RE: HARLOW STAGE 4 - AMENDMENTS TO CONSTRUCTION PLAN APPROVAL

Please be advised that the amended construction plans submitted to Council for Harlow Stage 4 are approved.

RE: HARLOW STAGE 4 - CONSTRUCTION PLAN APPROVAL

HARLOW ESTATE STAGE 4

**HARLOW ESTATE
STAGE 4
CROSS SECTIONS - RUMBEE CRESCENT**

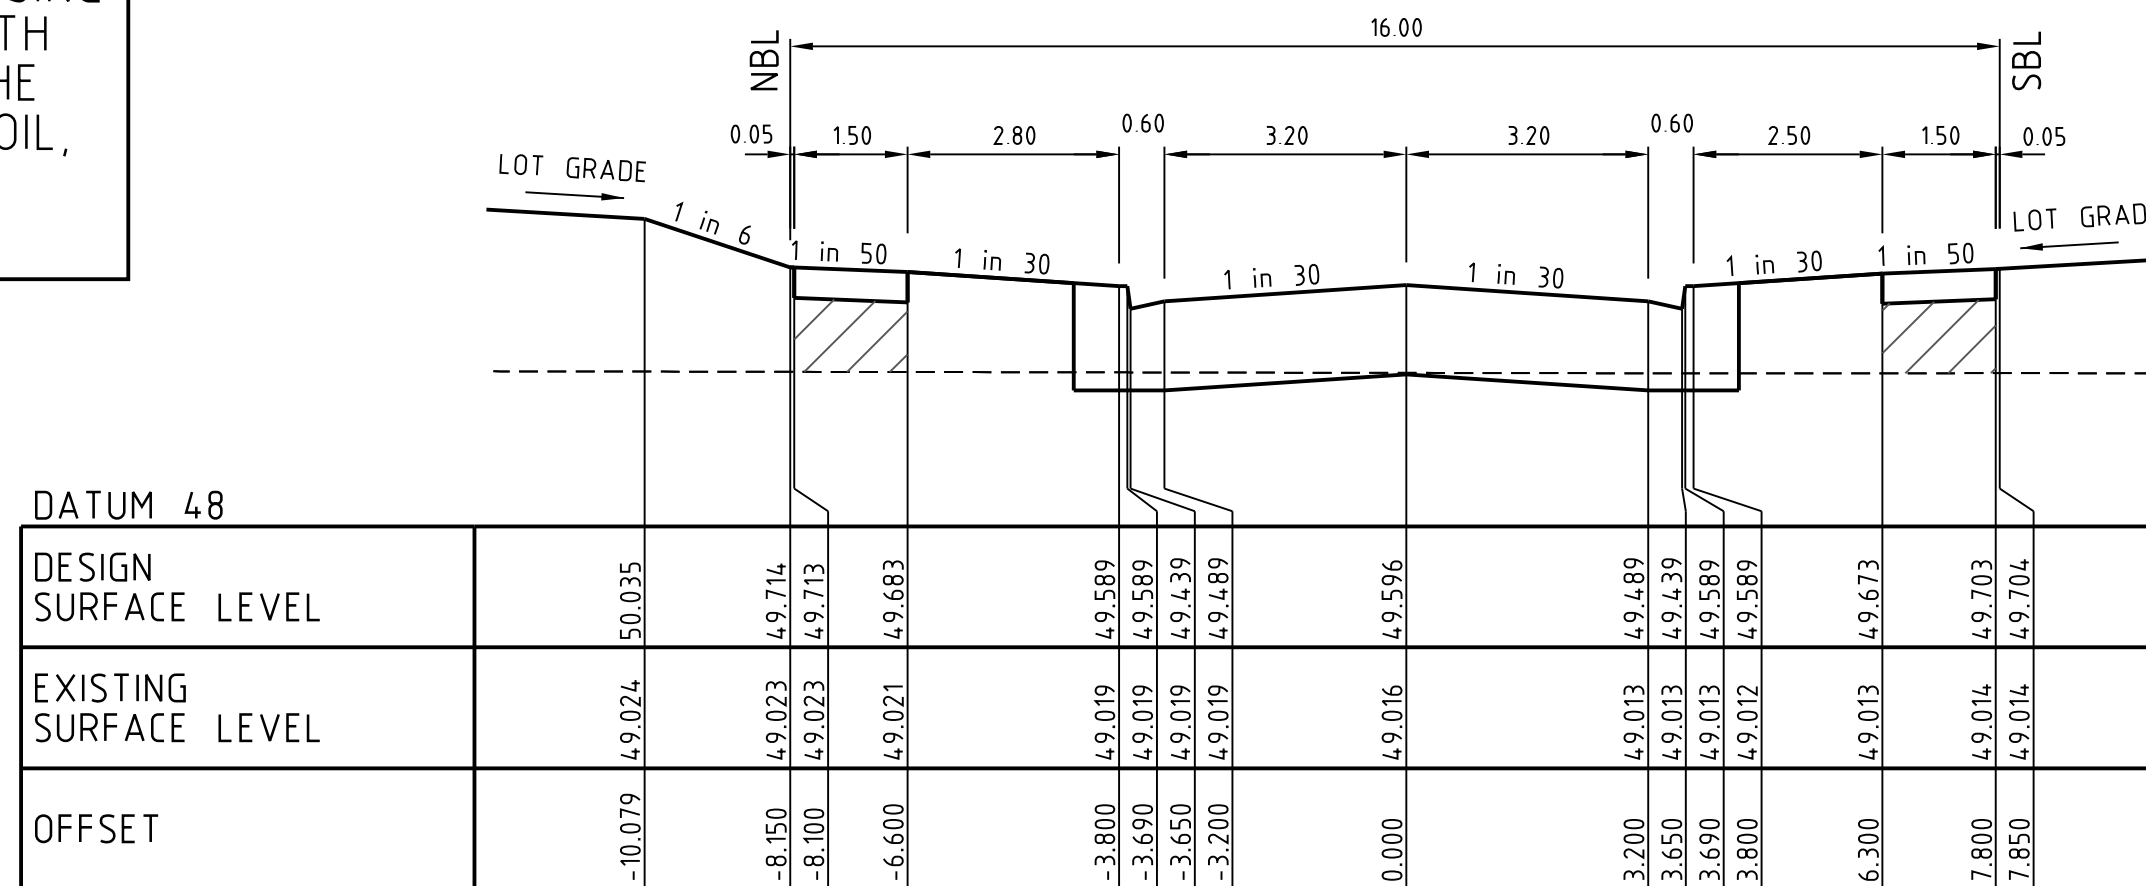
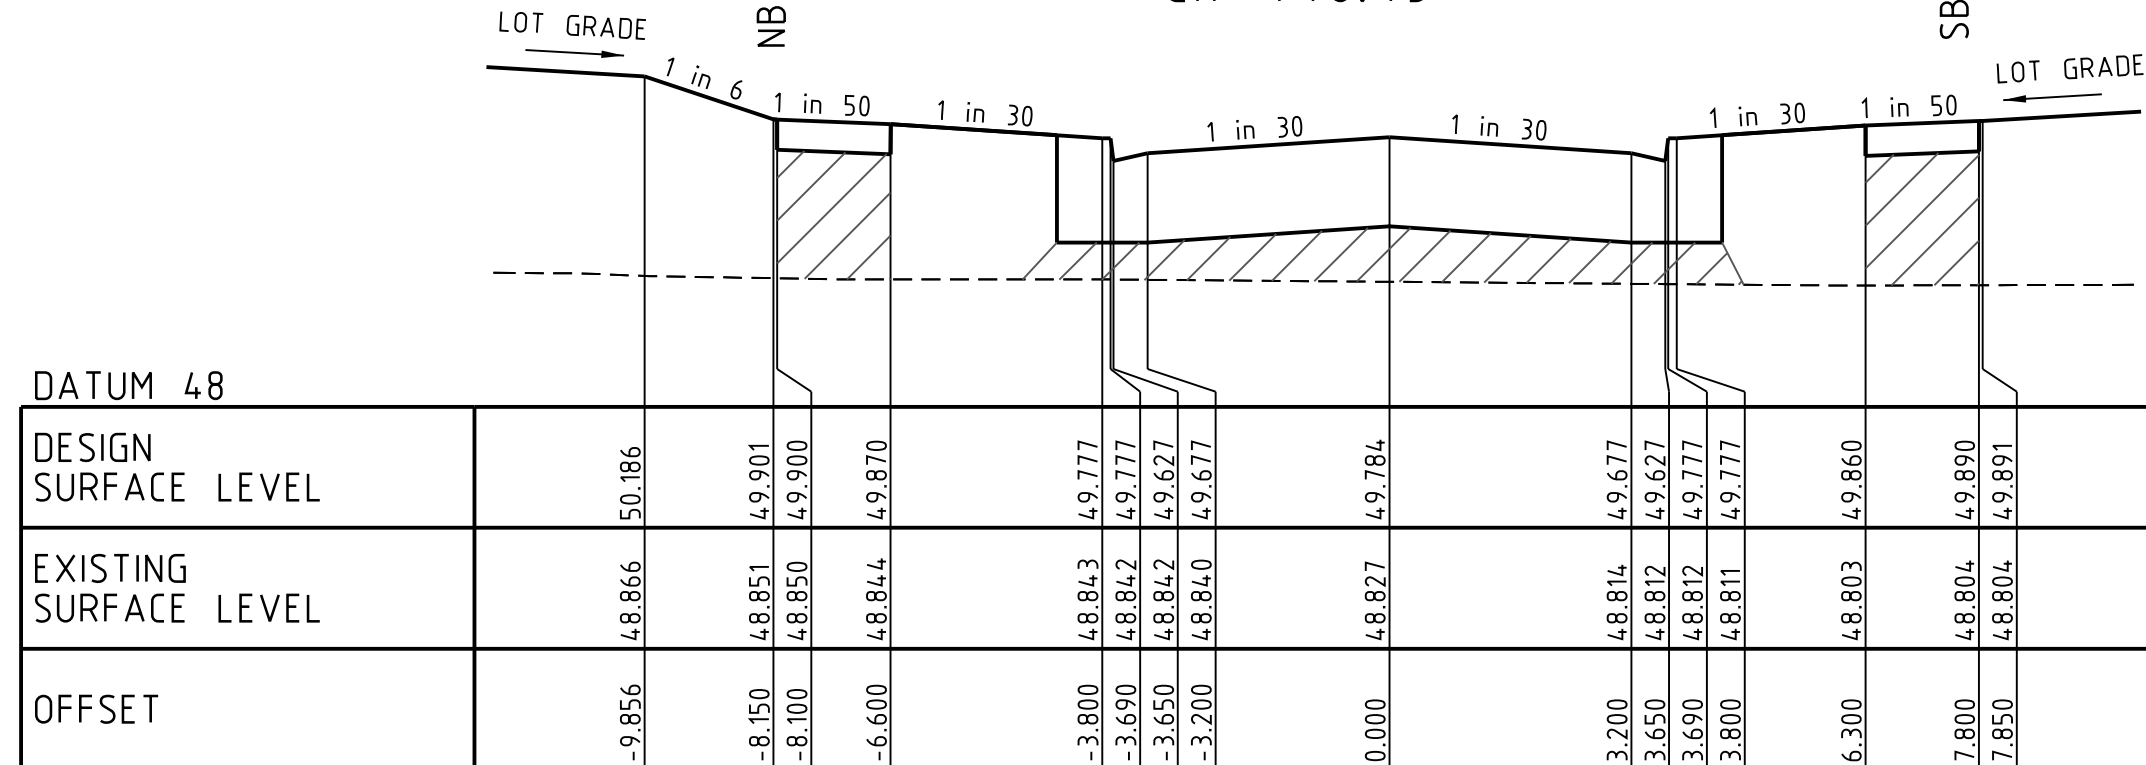
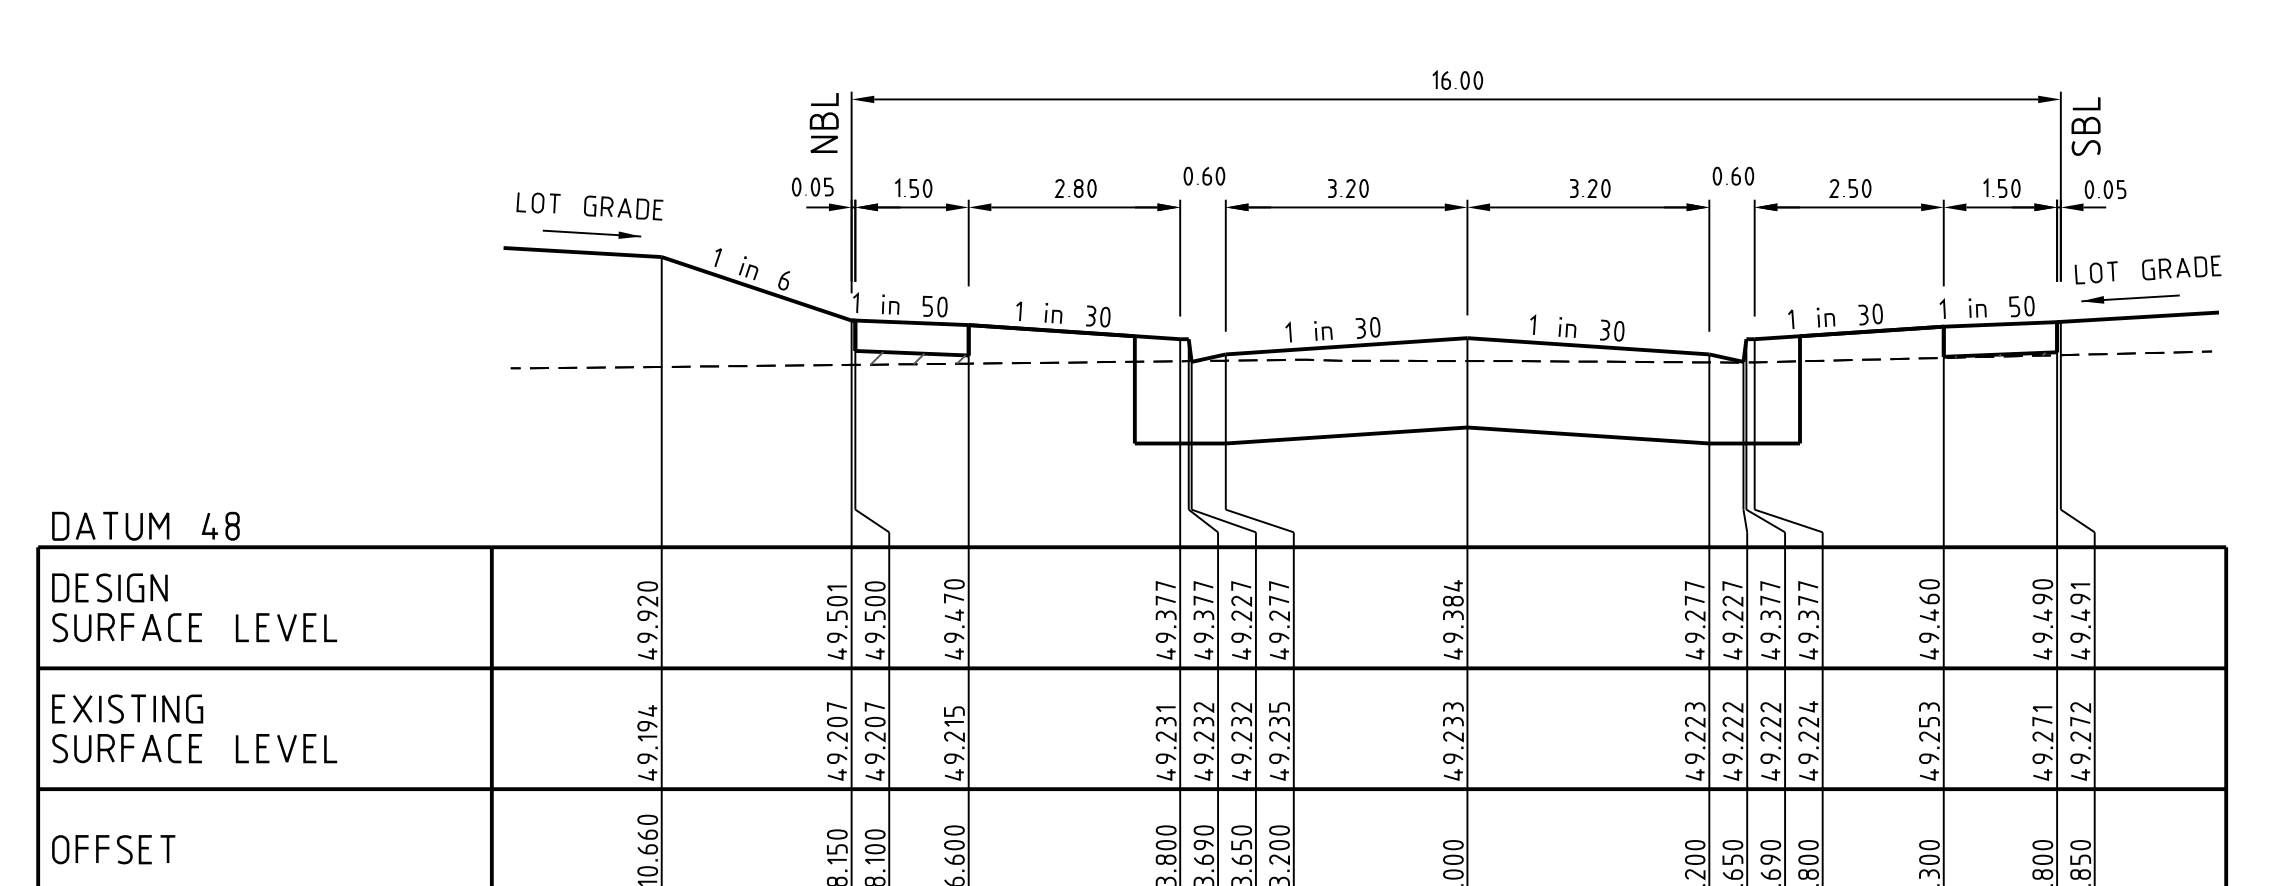
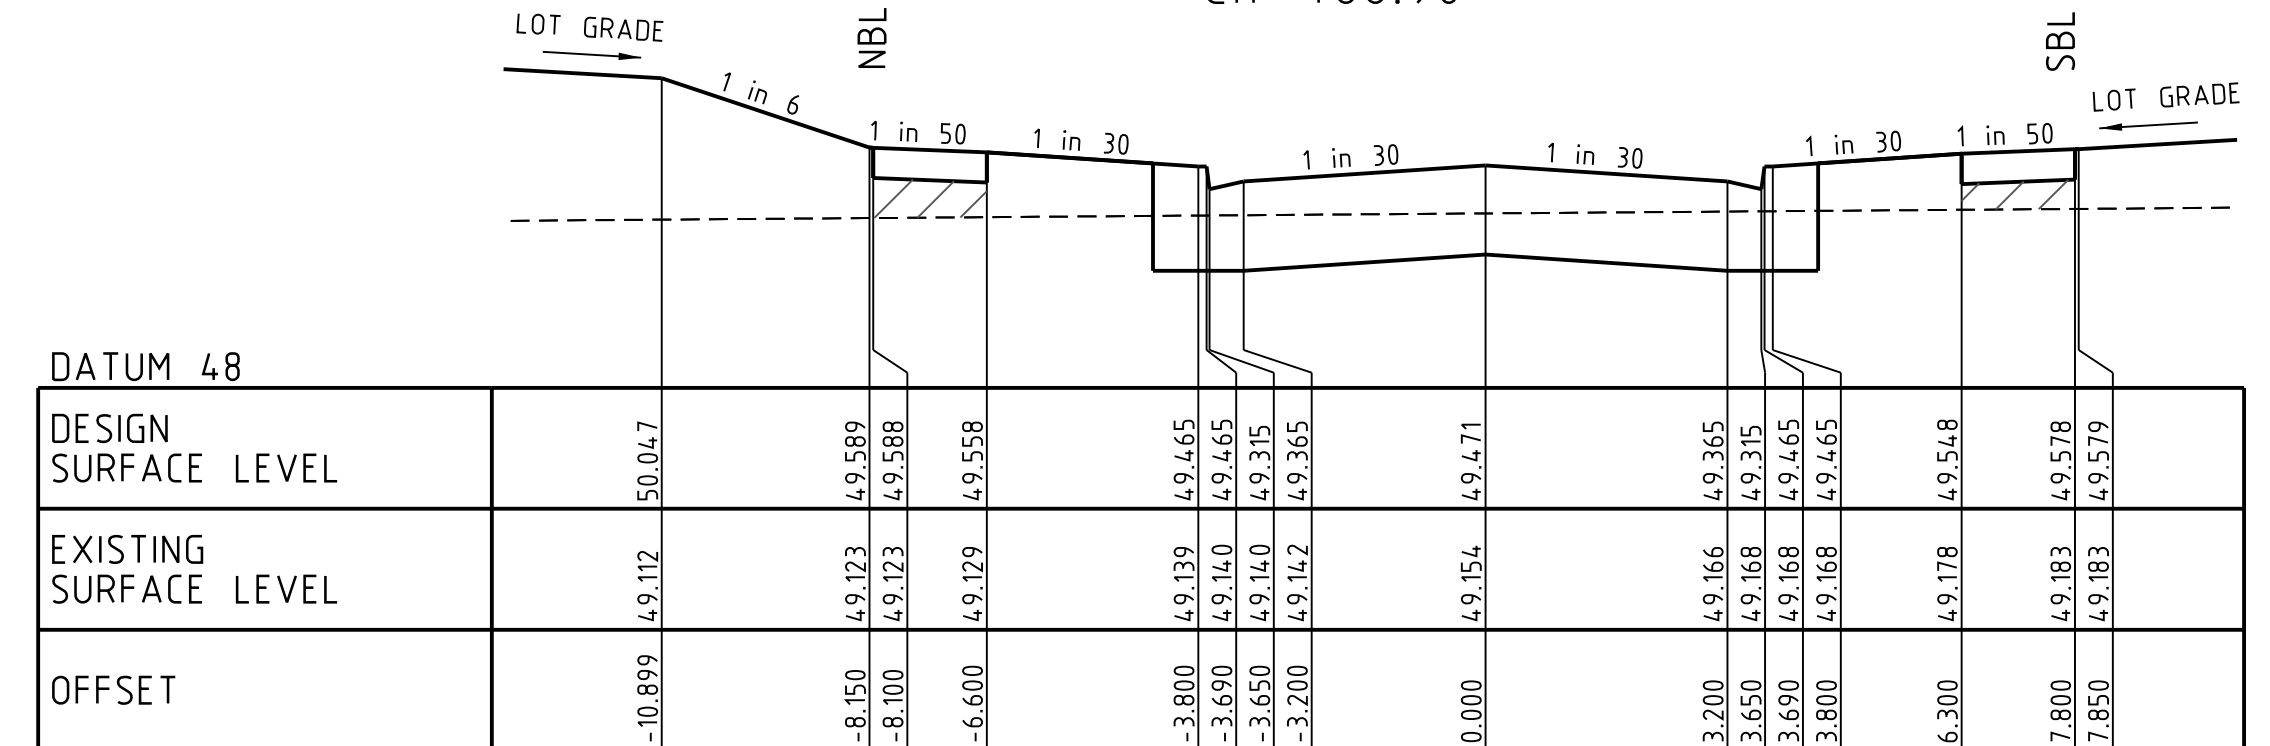
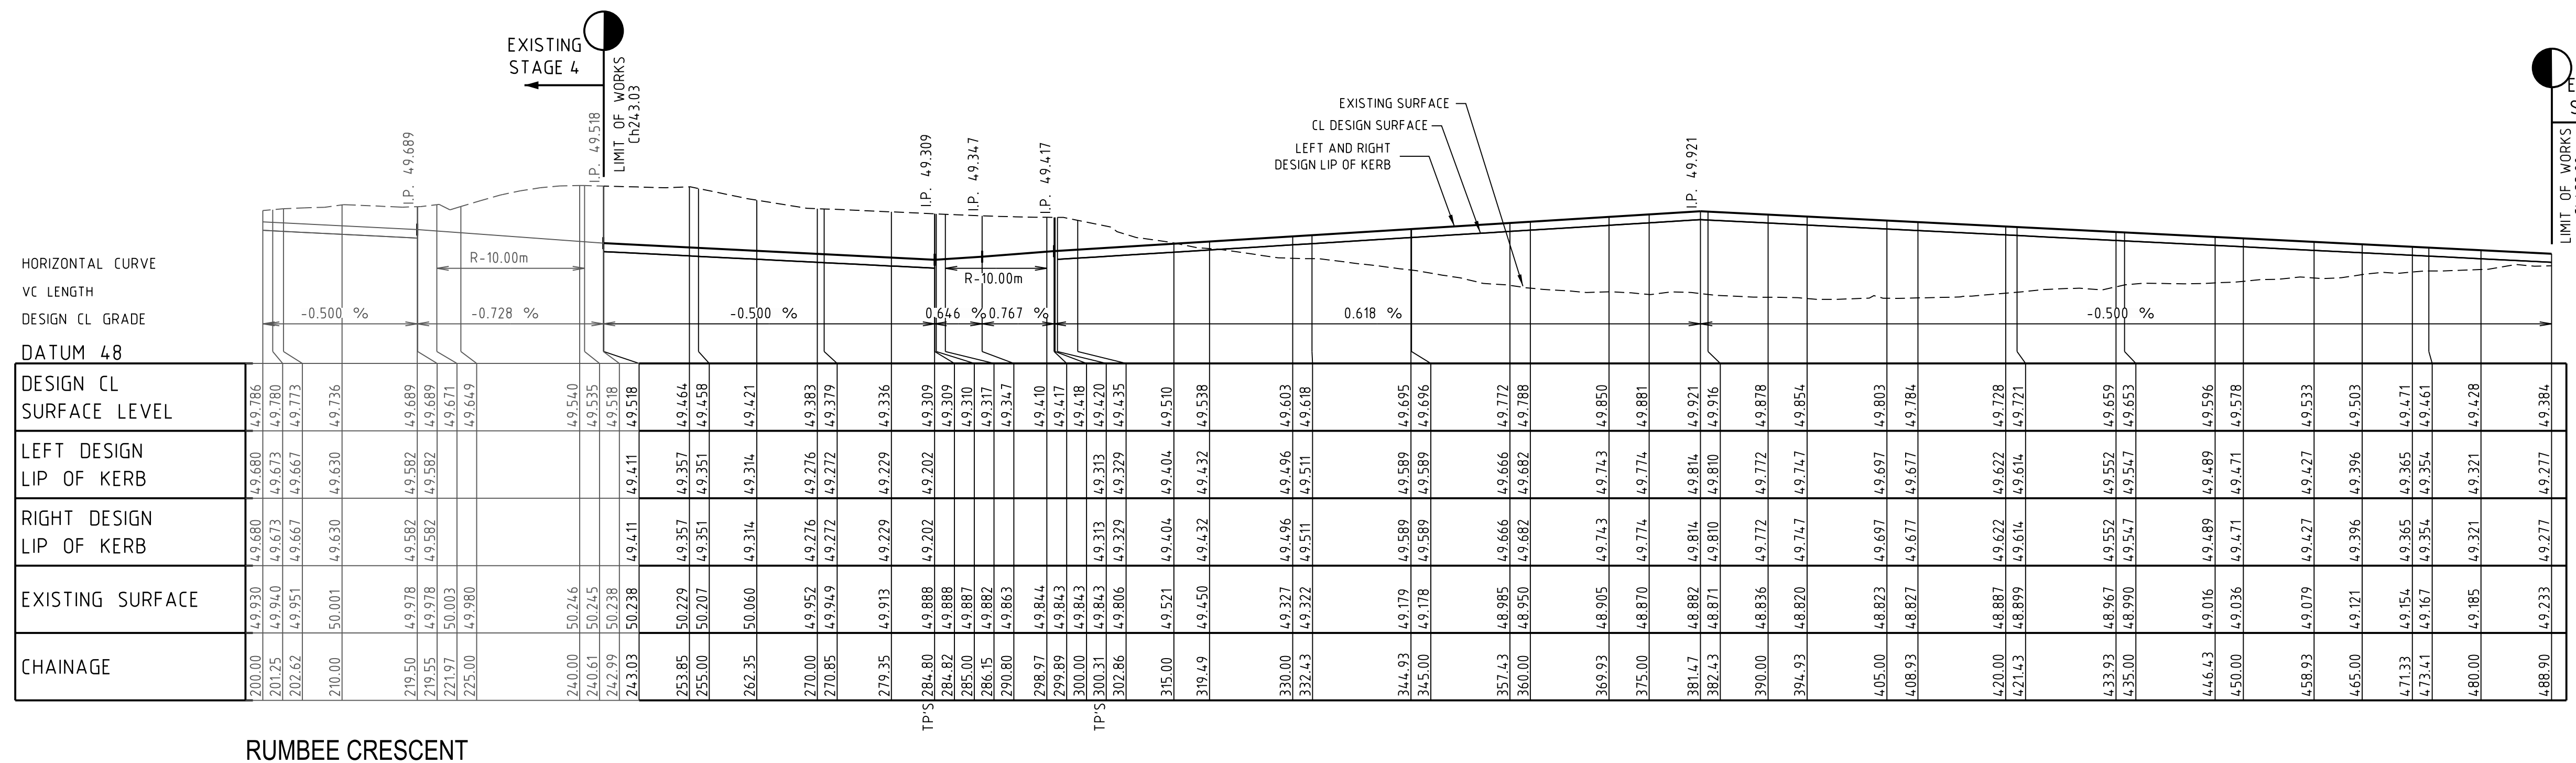
Rev	Amendments	Approved	Date
D	VERGE CROSS FALL UPDATED TO 1 in 30	M.R	31/10/23
C	COUNCIL COMMENTS ADDED	M.R	31/08/23
B	COUNCIL COMMENTS ADDED	M.R	15/06/23
A	ISSUE TO COUNCIL	M.R	10/02/23
